Field Service Action 22B44

SUBJECT: 22B44 - MONDEO - FRONT BRAKE FLEXIBLE HOSE REPLACEMENT

22B44: Mondeo/S - Front Brake Flexible Hose Replacement

FIGURE 2

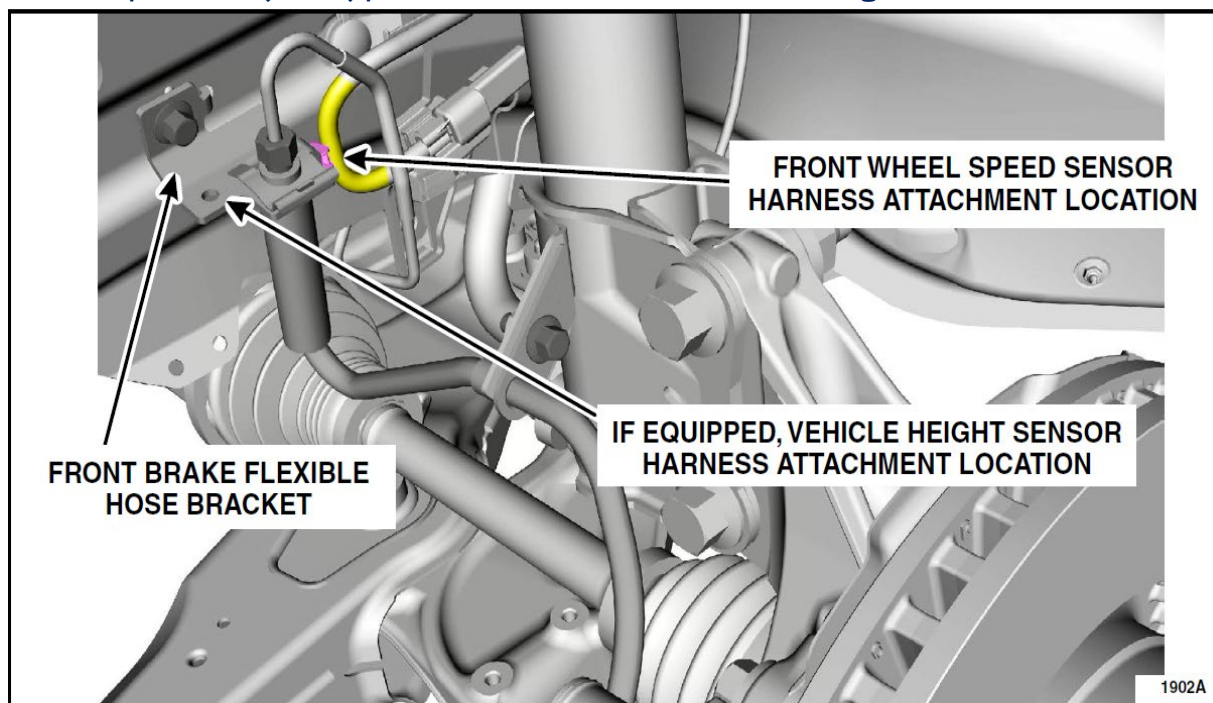
2. Replace the Right Hand (RH) and Left Hand (LH) front brake flexible hoses. Please follow Workshop Manual (WSM) procedures in Section 206-03. See Figure 2

FIGURE 1

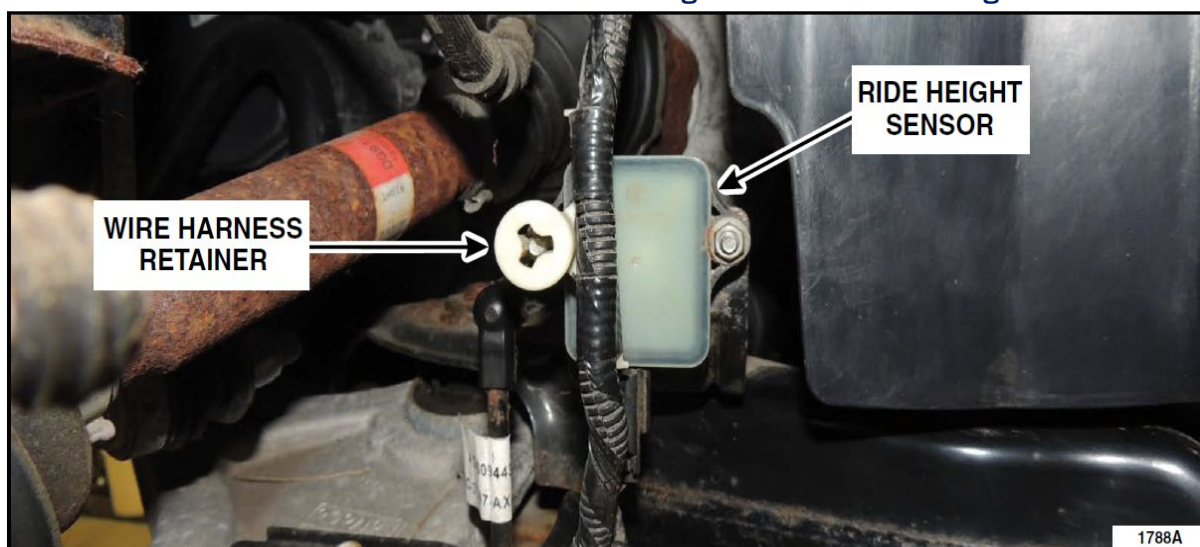
4. Remove the wire harness retainer from the ride height sensor stud. See Figure 1.

FIGURE 2

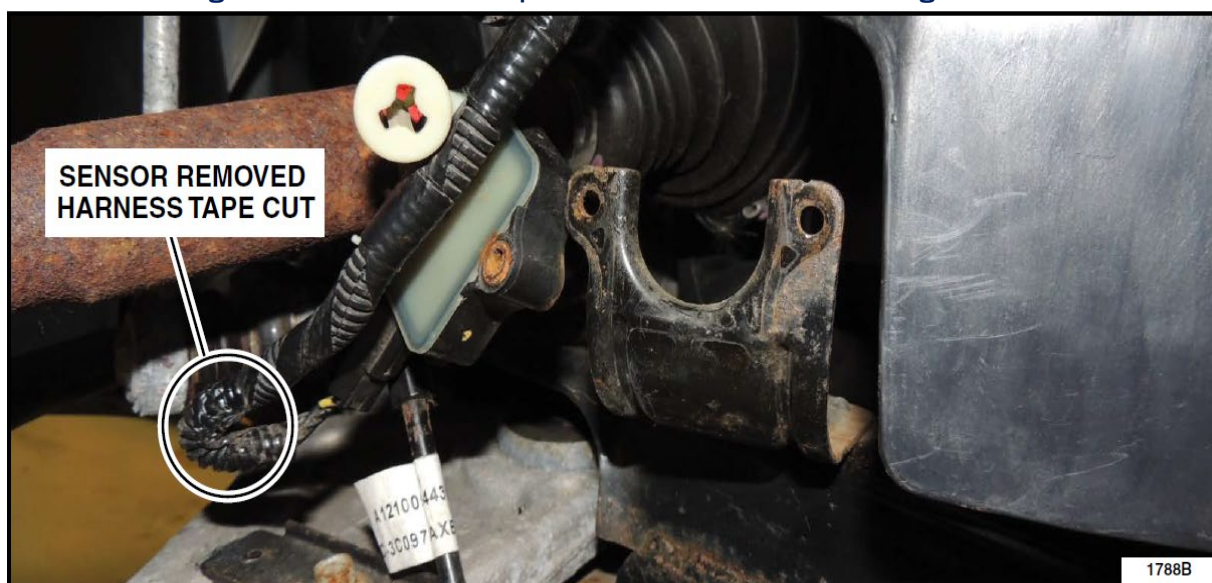
5. Remove the nuts and bolts from the ride height sensor and position aside. See Figure 2.
6. Cut the ride height sensor's harness tape at the harness bend. See Figure 2.

FIGURE 3

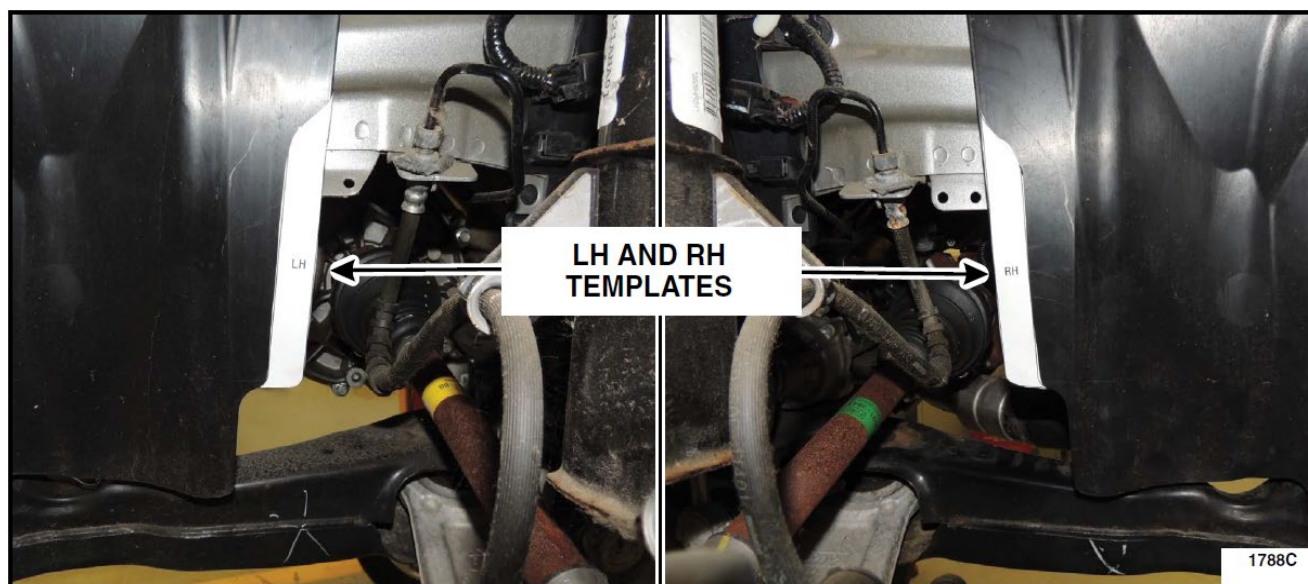
7. Attach the cut-out templates (See Attachment IV) to the RH and LH front fender splash shields. Using a suitable cutting tool, cut the front fender splash shields at the locations shown. See Figure 3.

NOTE: Remove any burrs or sharp edges.

NOTE: The front fender splash shields should remain on the vehicle during cutting.

FIGURE 5

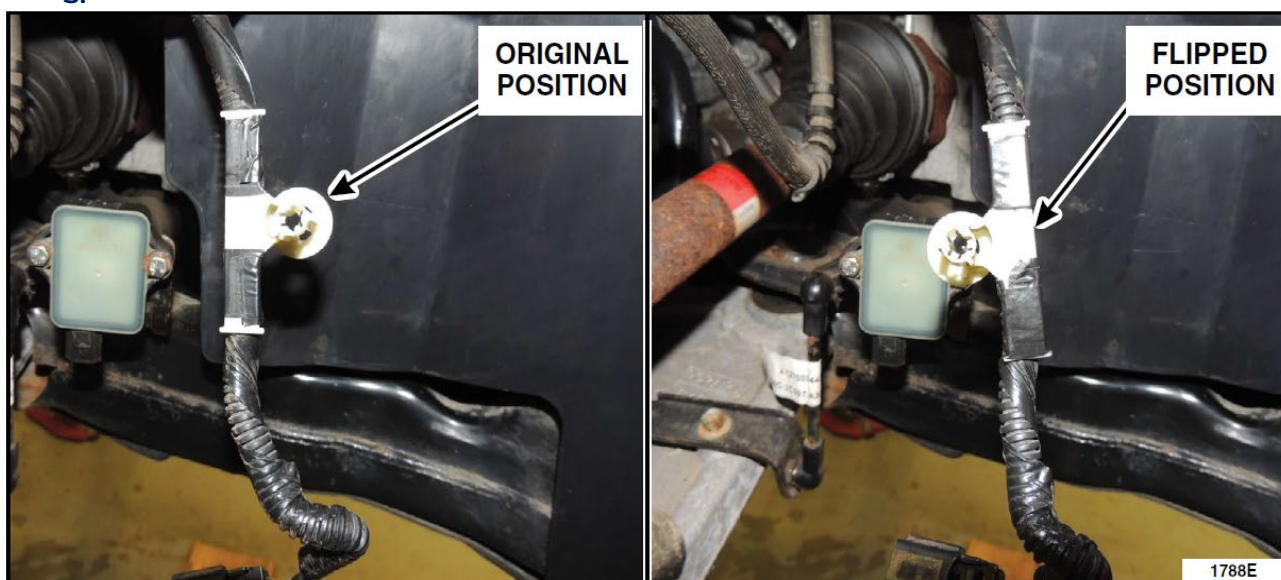
9. Mark the location of the clip on the ride height sensor's wire harness. See Figure 5.
10. Remove the tape and clip from the ride height sensor's wire harness. Rotate the clips 180 degrees and reinstall onto the ride height sensor's wire harness with electrical tape. See Figure 5.

FIGURE 6

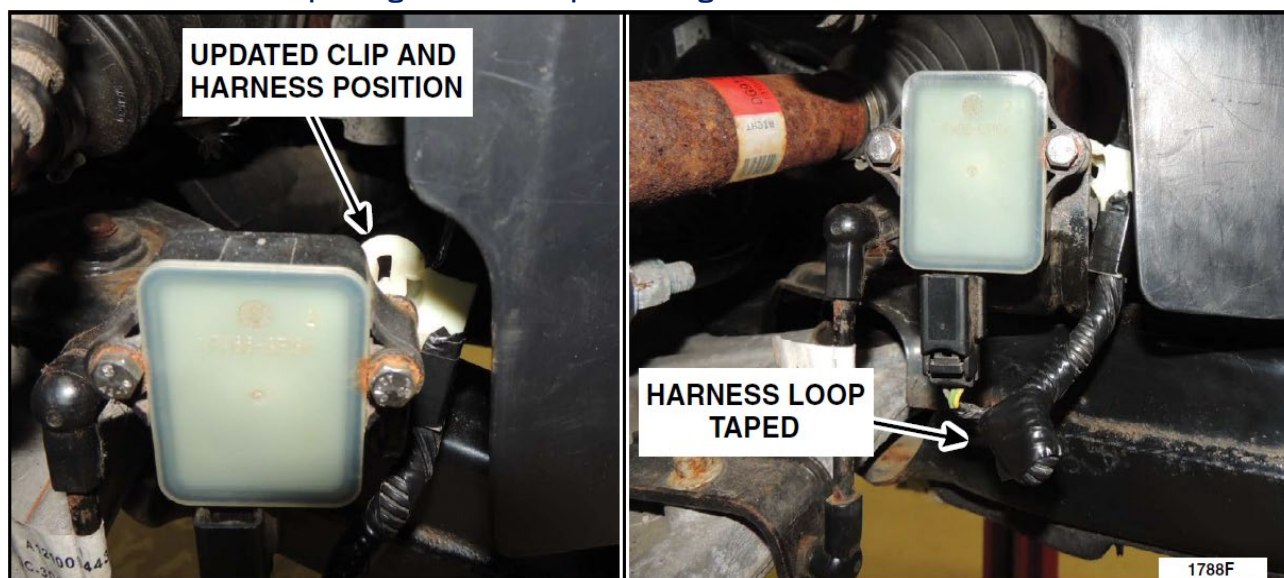
11. Attach the ride height sensor's wire harness clip to the front bracket bolt (long bolt) and secure the harness loop using electrical tape. See Figure 6.
